ITEM E04

CERTIFICATE OF APPROPRIATENESS

Property: 702 Euclid Street, Lot 2, Block 37, Woodland Heights Addition. The property

Proposal: New Construction - Garage

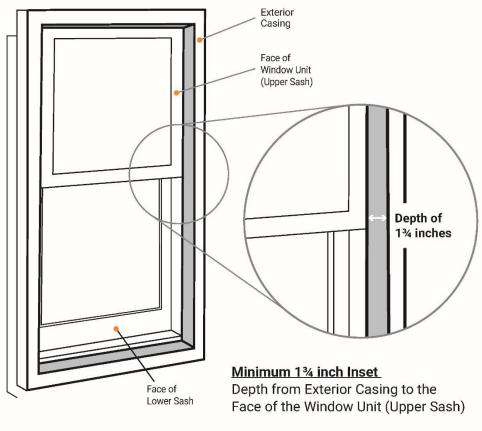
Windows must be 1-over-1 (equally horizontally divided)

134 inch minimum inset for Fixed Window
